ADDENDUM # 002

St. Joseph Catholic School
535 Birchbank Drive
Corunna, Ontario

Classroom Renovations

ADDENDUM NO. 1

SKM2

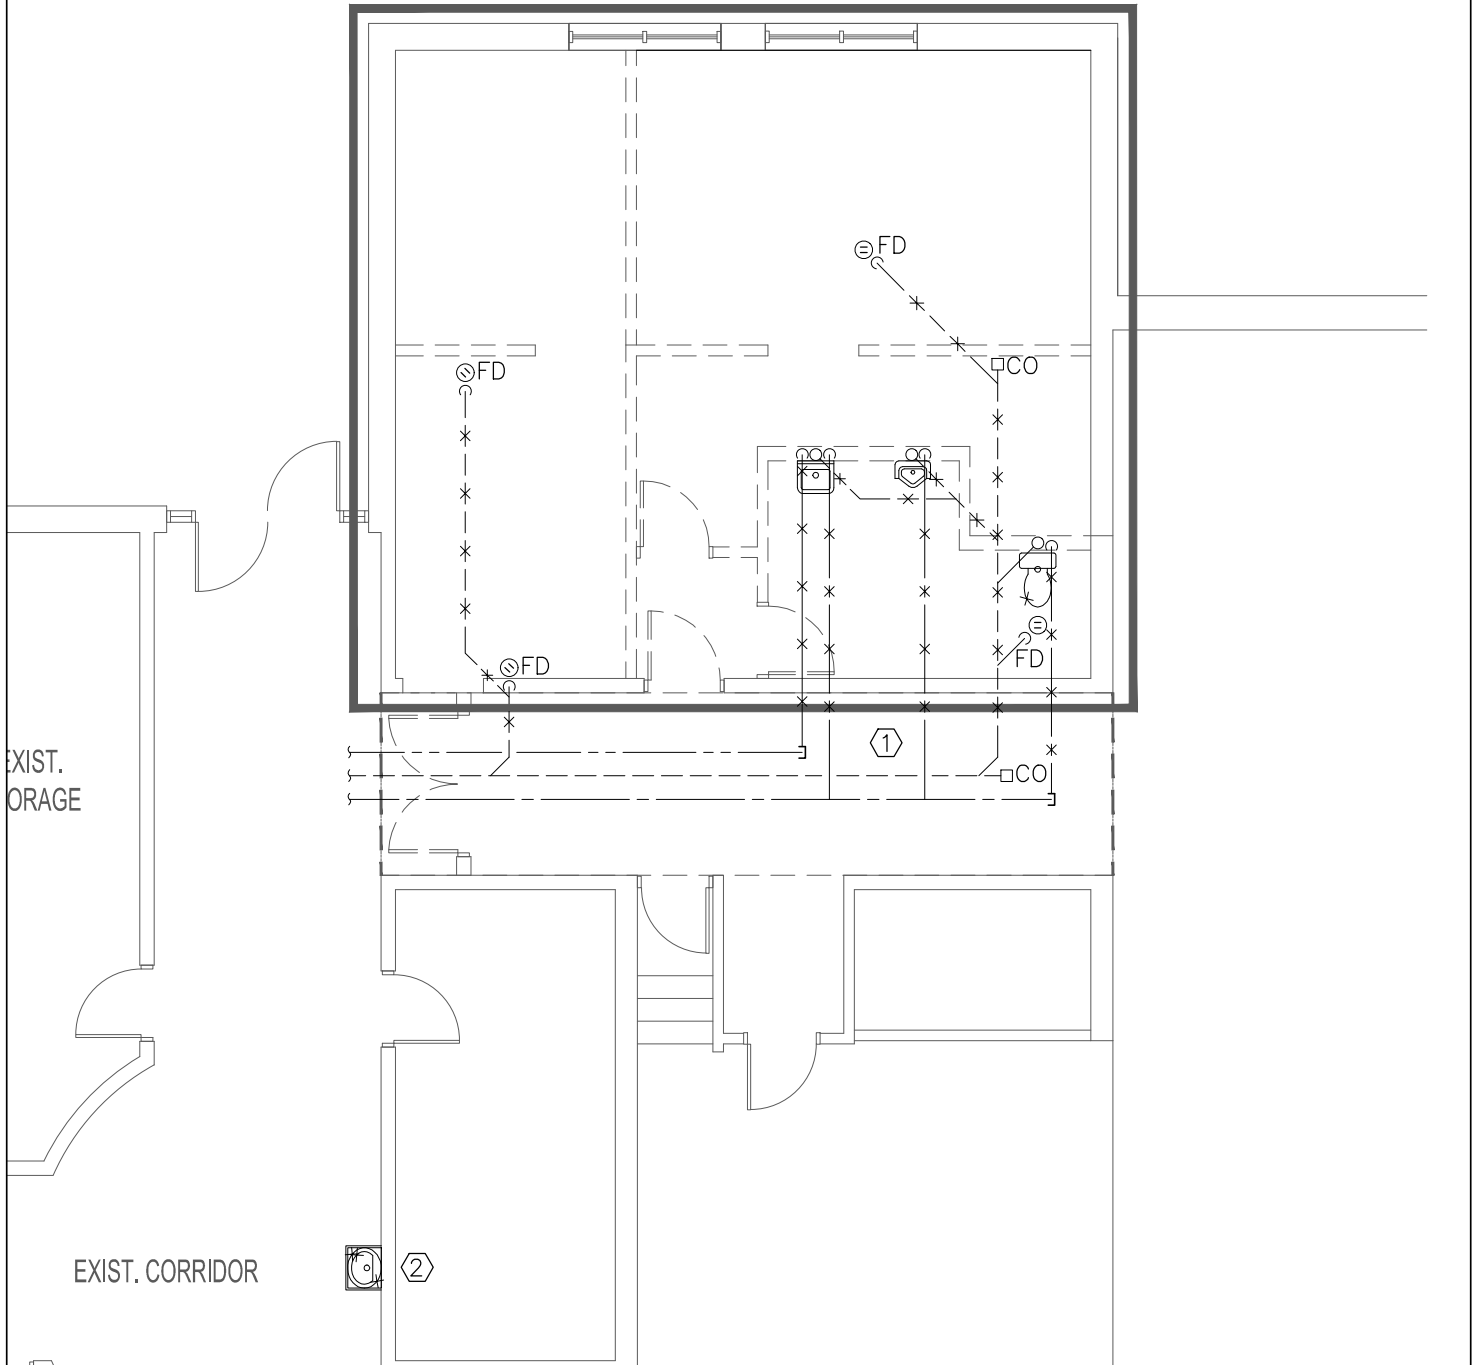
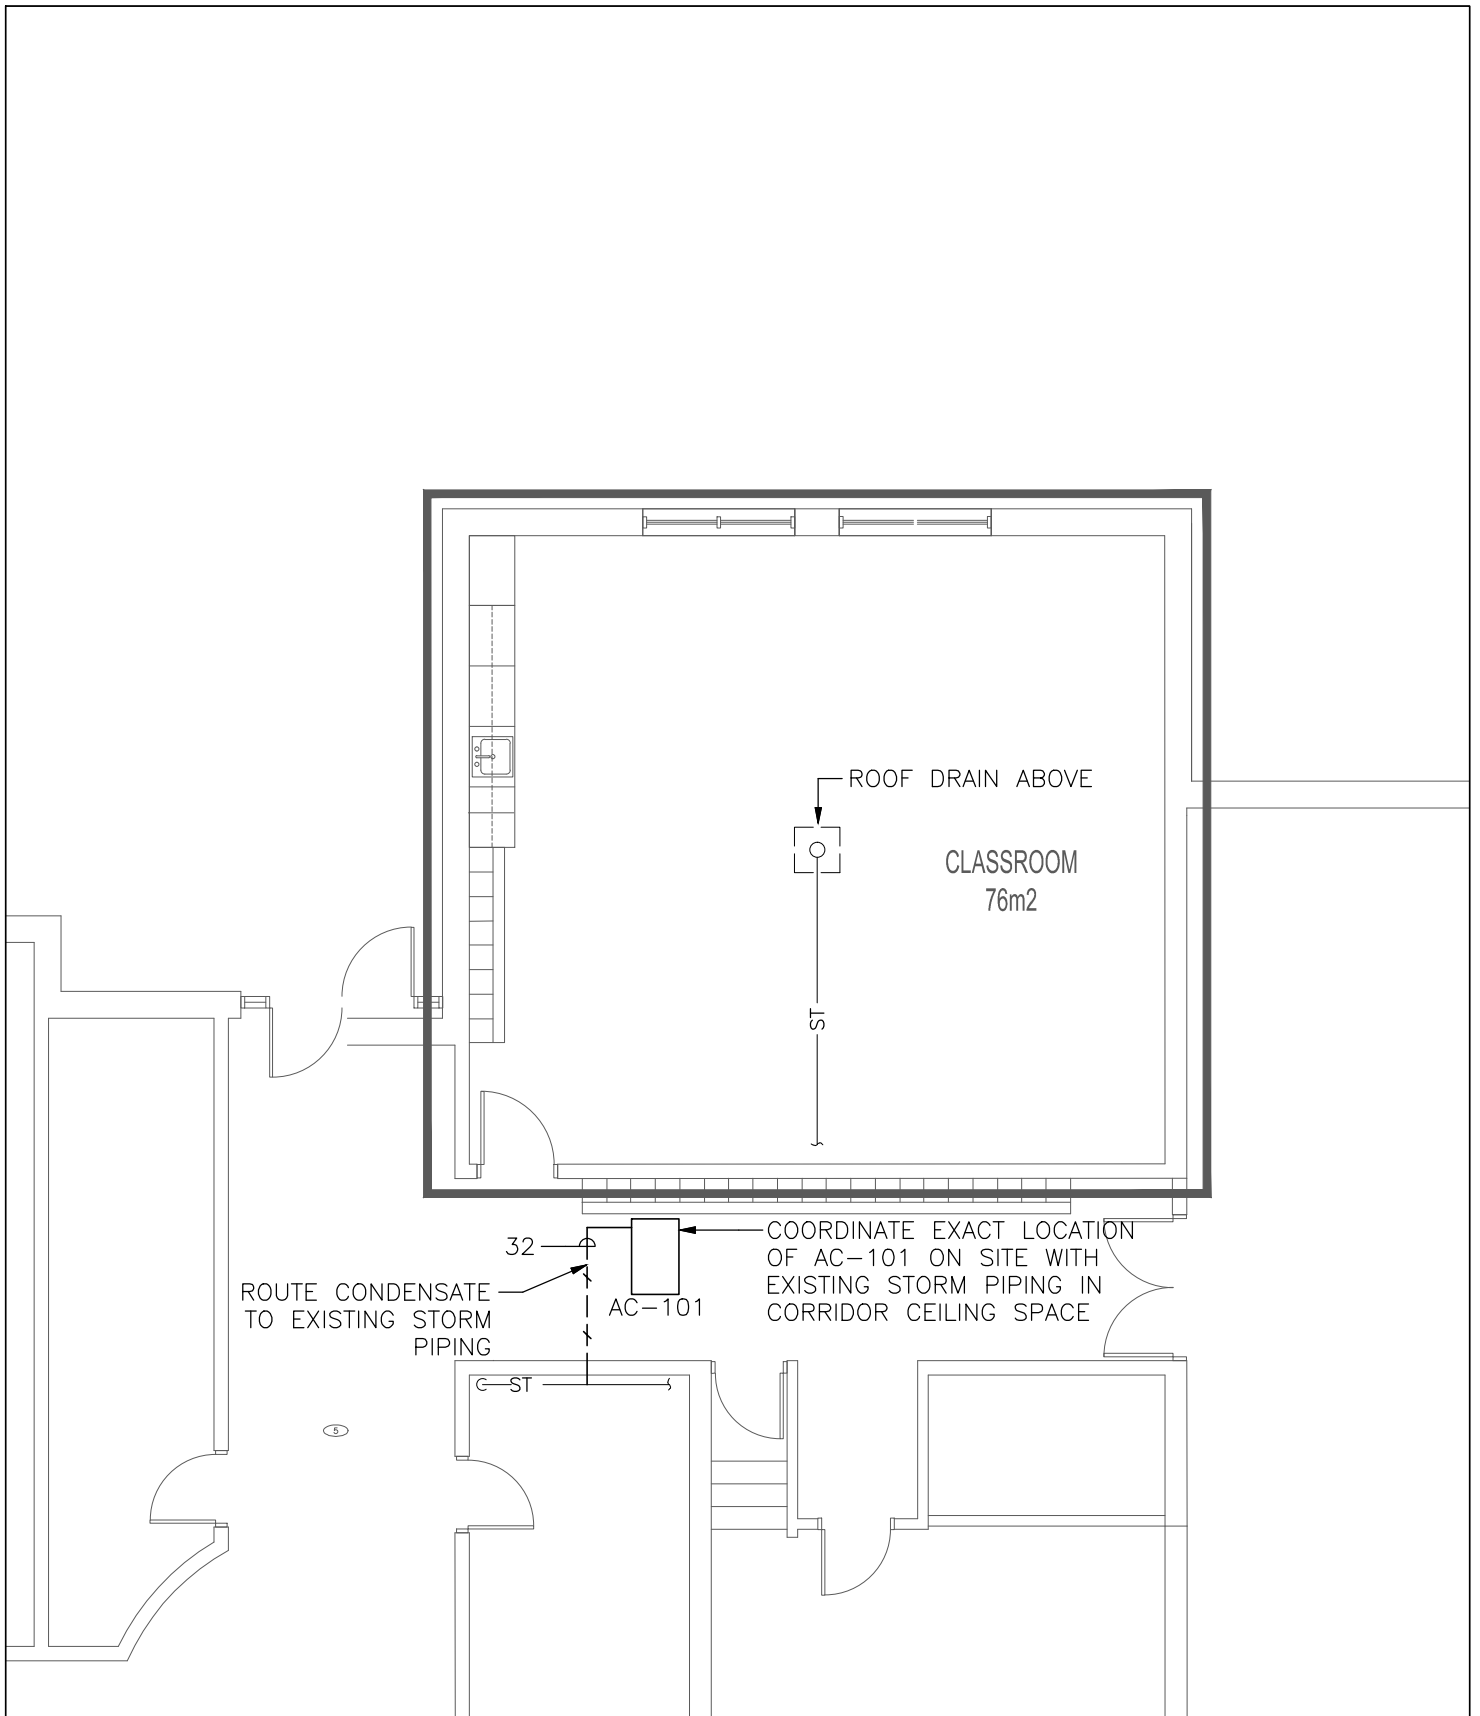
- 1.3. DWG M1 of 5
 - 1.3.1. New Plumbing and Sanitary Layout - Co-ordinate the final location of the new AC-101 with the existing storm drain routing in the ceiling space of the corridor.

- 1.3.2. New Plumbing and Sanitary Layout - Re-route the condensate drain from AC-101 to the existing 150mm RWL. Provide new fitting on existing RWL to accept new drain connection. Remove and repair existing insulation as required.

- 1.3.3. Plumbing and Sanitary Demo Layout – Add demolition note 4.
 - 1.3.3.1. Note 4. Disconnect and remove existing shower valves, shower heads and related shower drain from existing shower areas in both existing male and female change rooms. [four heads per shower area] Remove existing DCW and DHW piping from existing walls back to the accessible ceiling space. Cap the branch piping at the mains. Re-insulate any exposed piping caused by the demolition.
